SUPPLEMENT TO VOLUME THREE
ENVIRONMENTAL SETTING AND ASSESSMENT
FOR
A LIQUEFIED NATURAL GAS TERMINAL
GRASSY POINT, PORT SIMPSON BAY
NORTHERN BRITISH COLUMBIA

Dome Petroleum Limited

August 15, 1982

FOREWORD

Figure S3.1.1 Scatter diagram of peak period versus significant wave height.

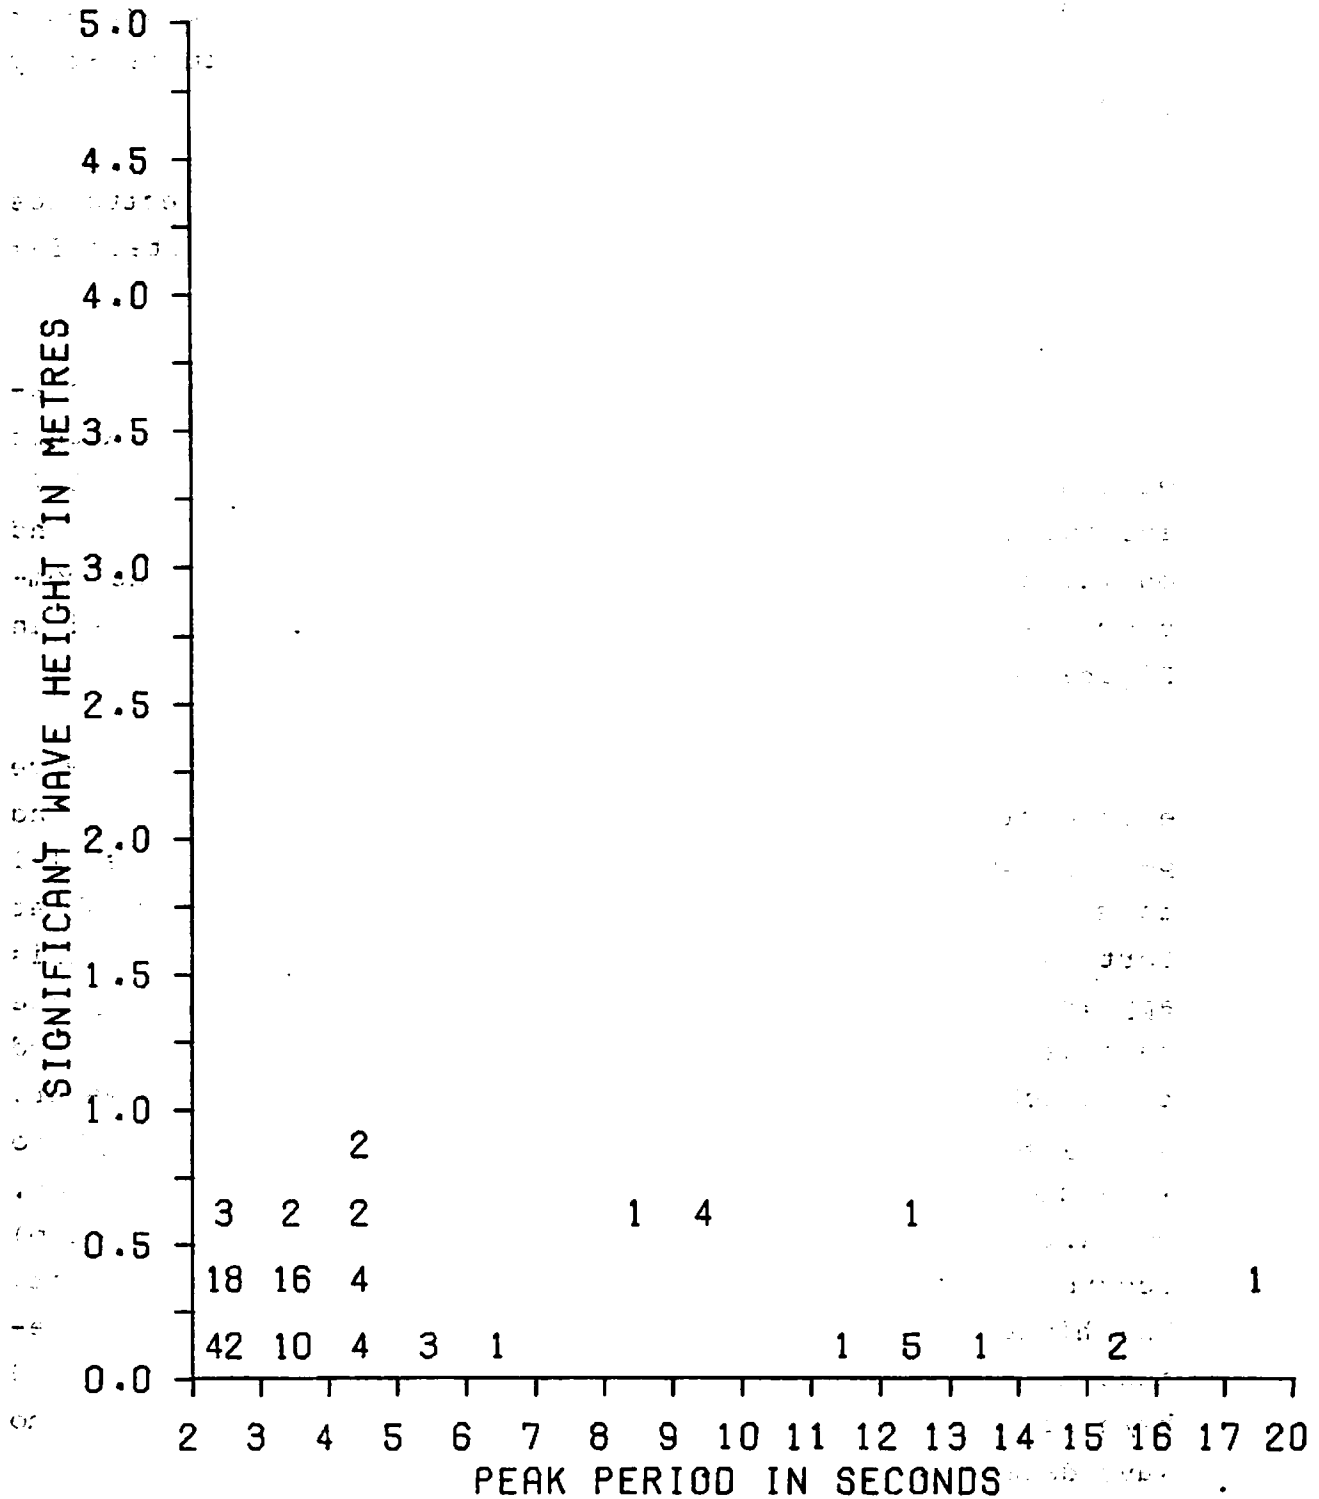
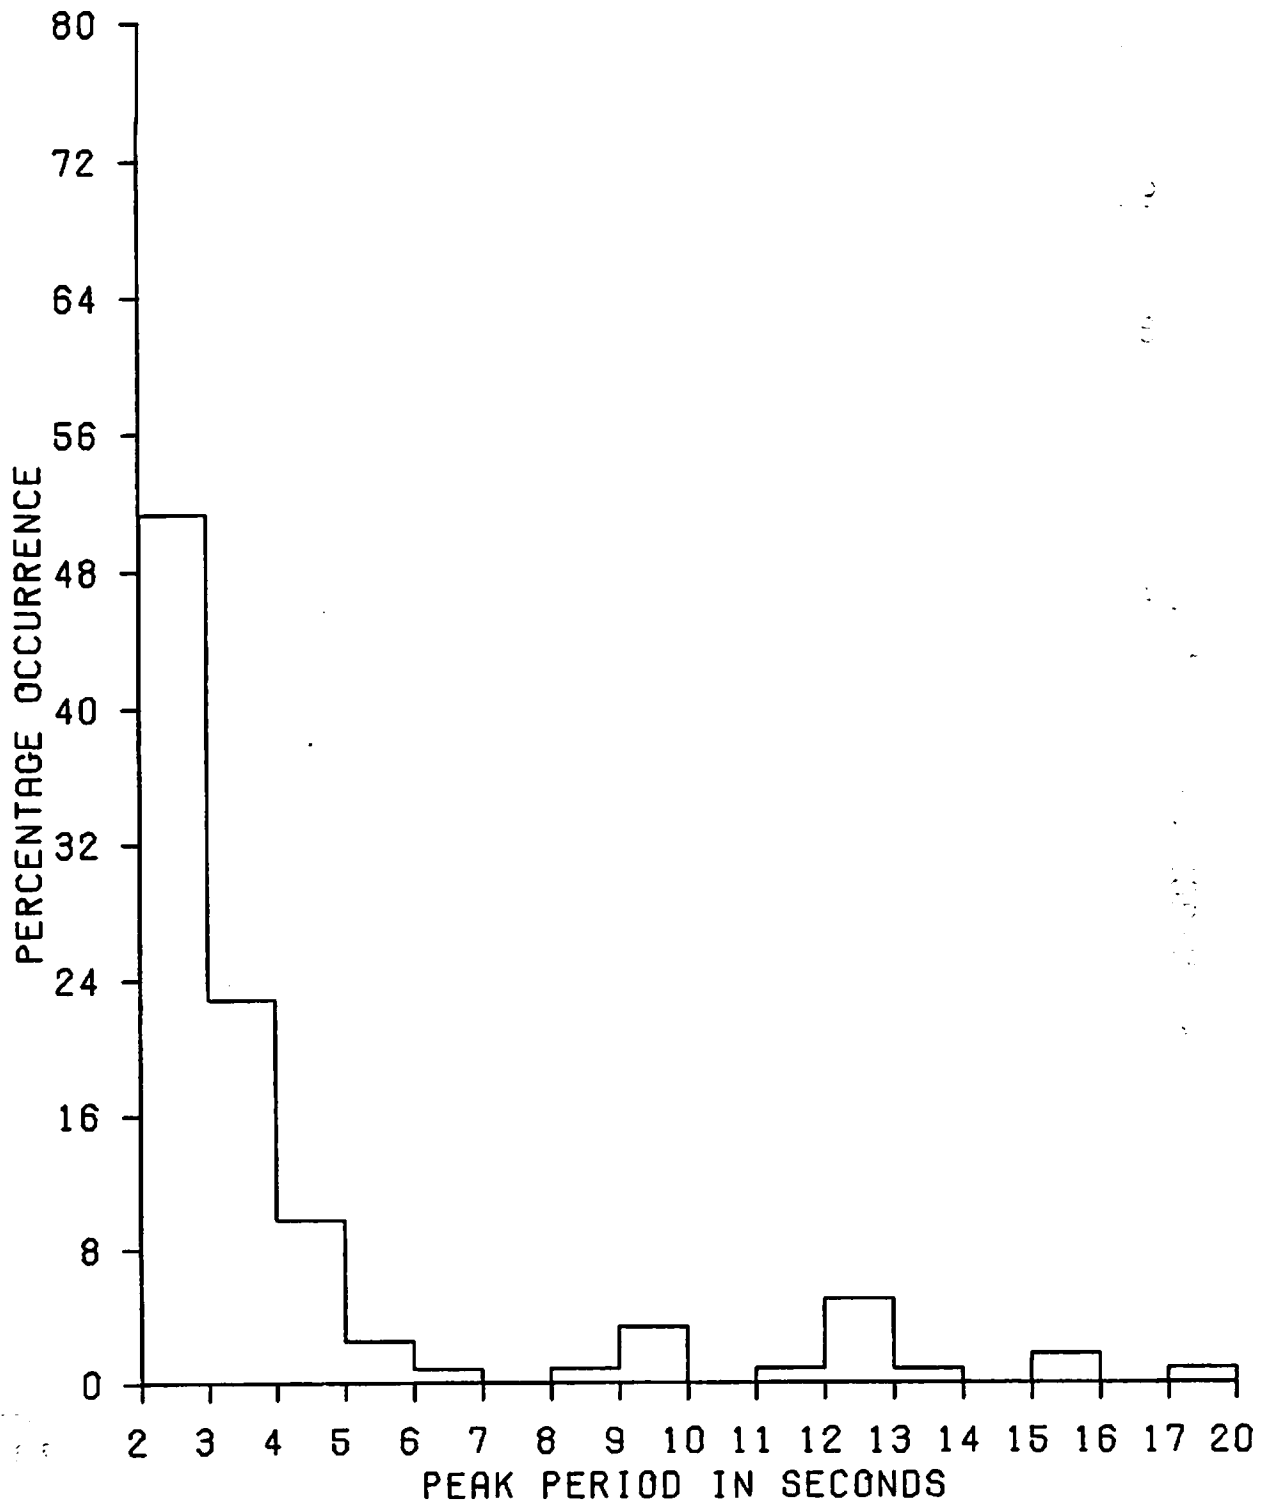
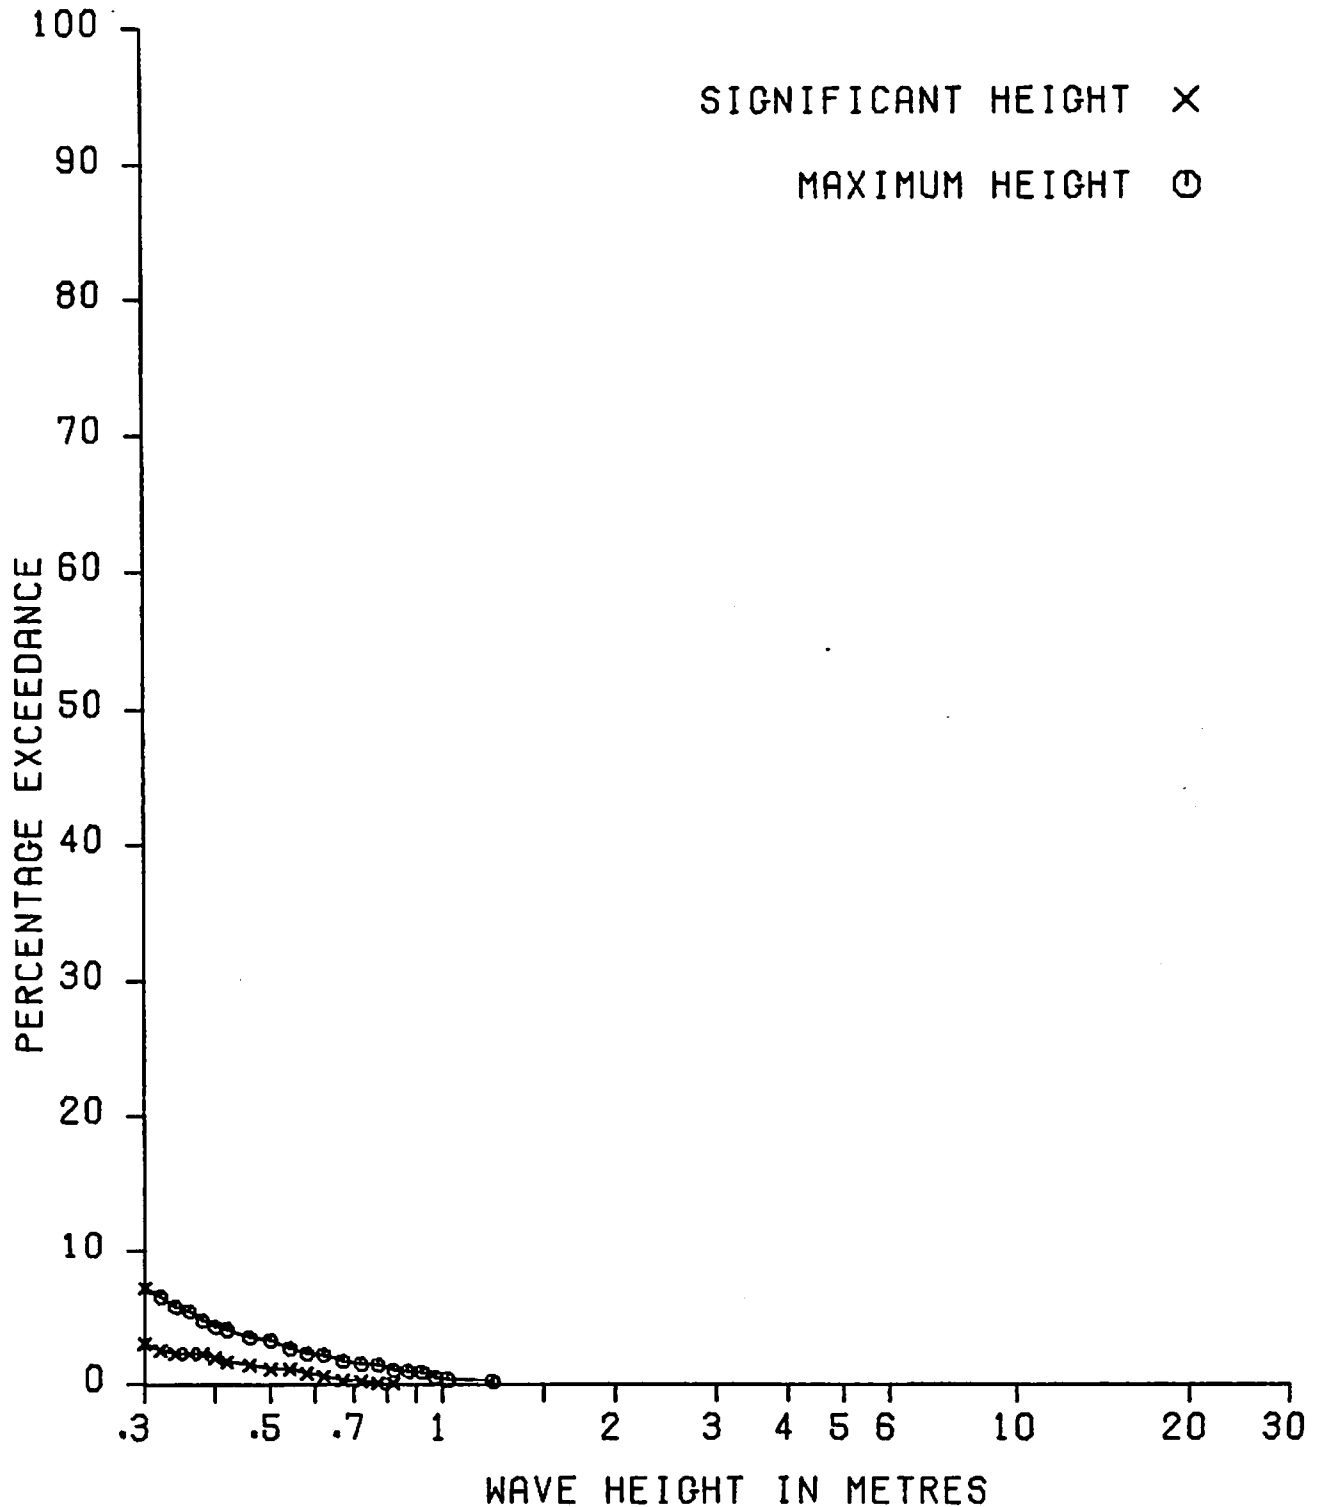
Due to the malfunction of the meteorological station at Port Simpson, the wind measurements at Prince Rupert were used for the months of January 1982 through March 1982; and for the first half of May 1981 to evaluate effect of wind on waves observed. The statistical evaluations of the complete wave record collected at Port Simpson are presented in Figures s3.1-1 to s3.1-3.

In general, the observations indicate very low wave energy at Port Simpson, with amplitudes less than 1 m and peak periods usually shorter than 5 seconds (Figures s3.1-1 to s3.1-3). The findings indicate that the wave field at Port Simpson is dominated by locally generated seas. This appears reasonable considering the protection offered by the various islands and reefs near the proposed dock site; and the fetch-limited nature of the surrounding waters. However, during some of the winter months (December and January) no wave record data were collected due to buoy malfunction. Overall the highest observed significant wave height (0.82 m) occurred January 14, during a one-day operation of the unit. The highest recorded wind event during the 1981-82 measurement happened December 9, when hourly winds greater than 60 km/hour from the north were recorded but, unfortunately, no wave data were recovered on that day.

**FIGURE S3-1.9 OCEANOGRAPHIC STUDY SITES
OCCUPIED BY DOME PETROLEUM LIMITED IN 1981**

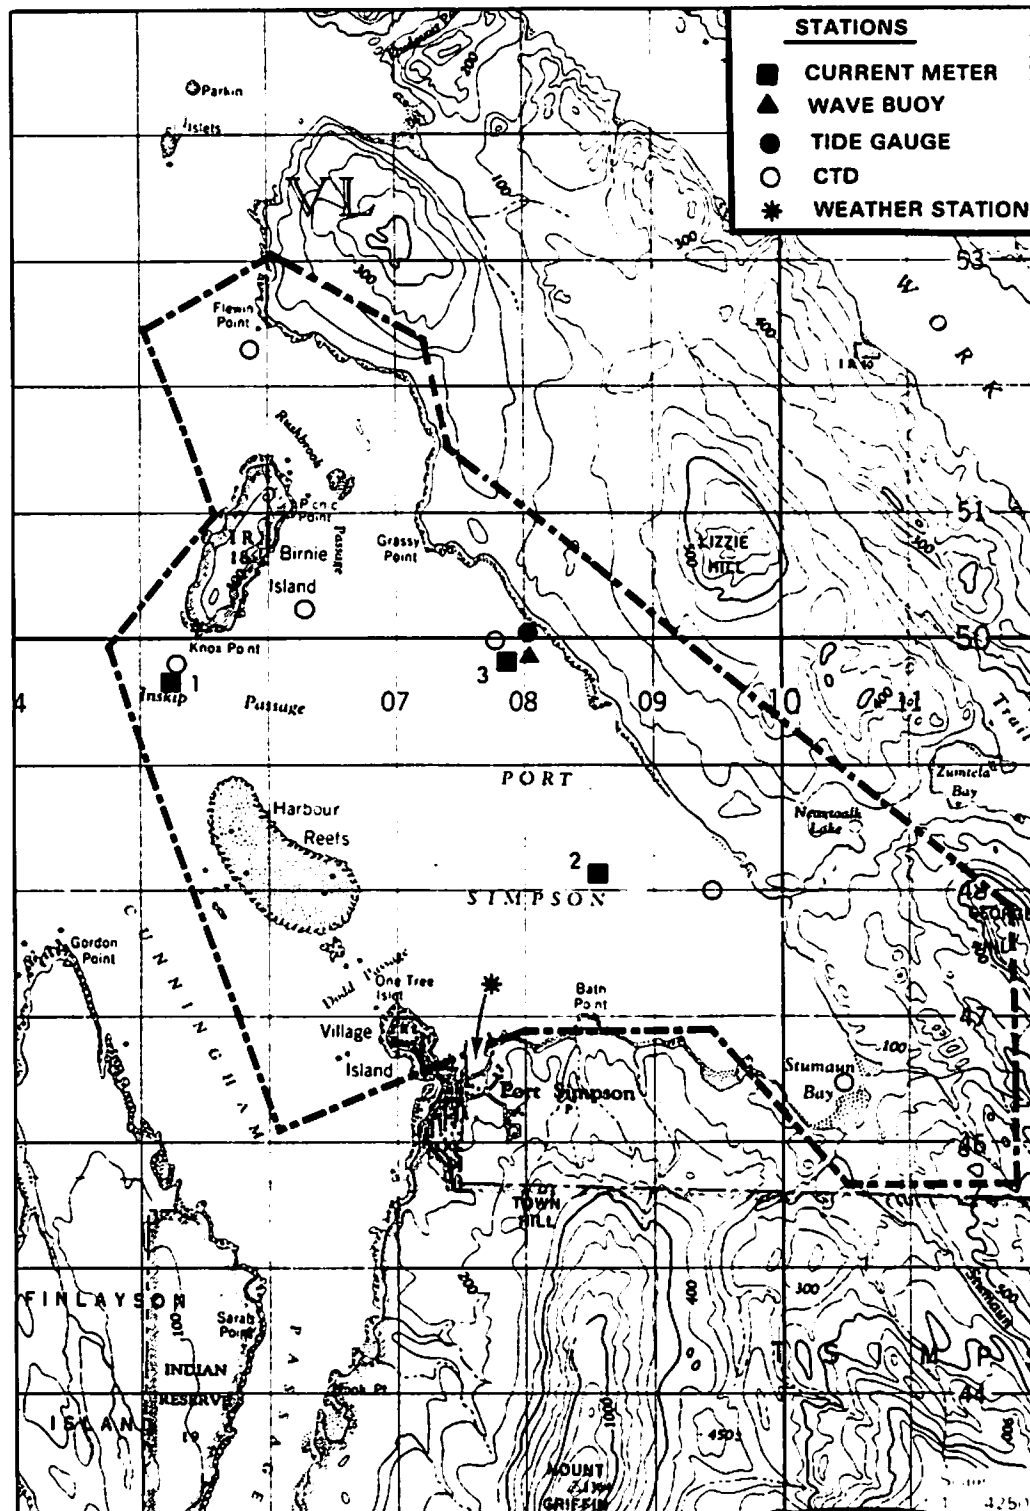
Page 3.1-40 Replace Figure 3-1.9 with Figure s3-1.9.

FIGURE S3-2.1 FREQUENCY OF WIND DIRECTIONS

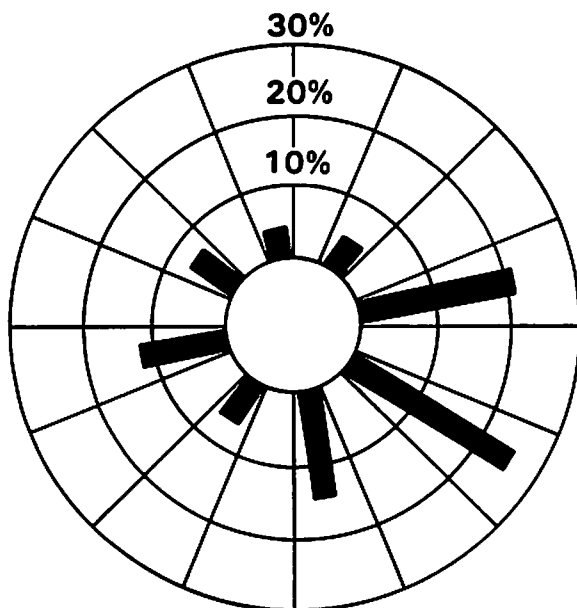
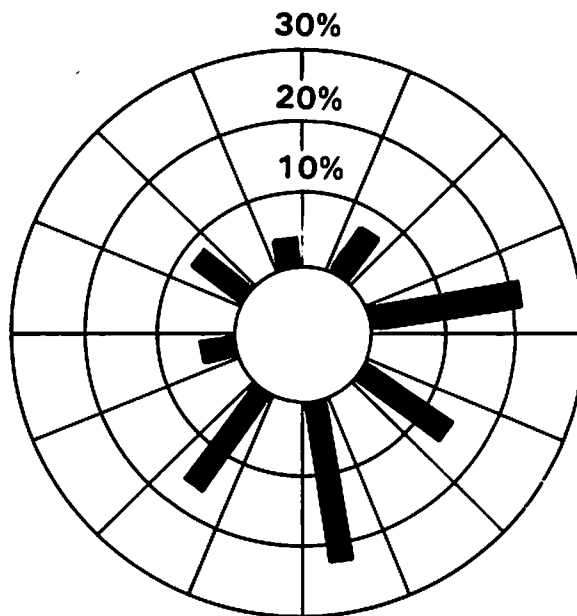
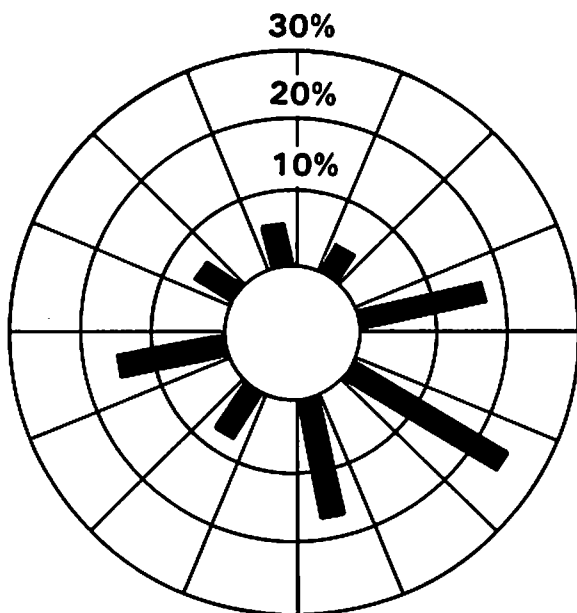
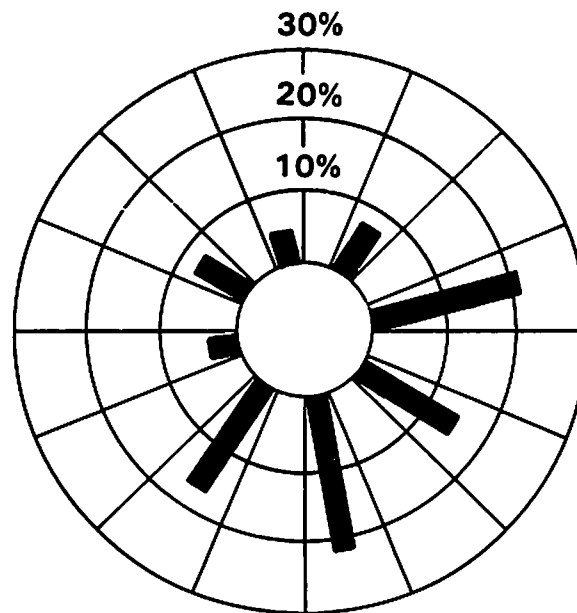
Topographic features at each station play a dominant role in dictating the prevailing wind patterns. A comparison of the mean monthly frequency of wind at Port Simpson (Table s3-2.1) and Prince Rupert (Table s3-2.2) together with a qualitative assessment of topographic effects suggests the following general patterns:

- a. The wind is most frequently from the SE at Prince Rupert. During these occasions, the wind at Port Simpson will most likely be from SSE, S or SSW. This is due to the influence of the topography of the Tsimpsean Peninsula.
- b. A wind from the west at Prince Rupert tends to exhibit a shift to a wind from WNW and NW at Port Simpson. This is likely due to the local influence of Village Island on the anemometer location at Port Simpson.

- c. A comparison of mean speeds (by direction) contained in Tables s3-2.1 and s3-2.2 indicate that on the average, speeds at Port Simpson are approximately 25 percent lower than those measured at Prince Rupert. Extreme hourly mean wind speeds and associated return periods for Port Simpson and Prince Rupert were estimated and are presented in Table s3-2.3.
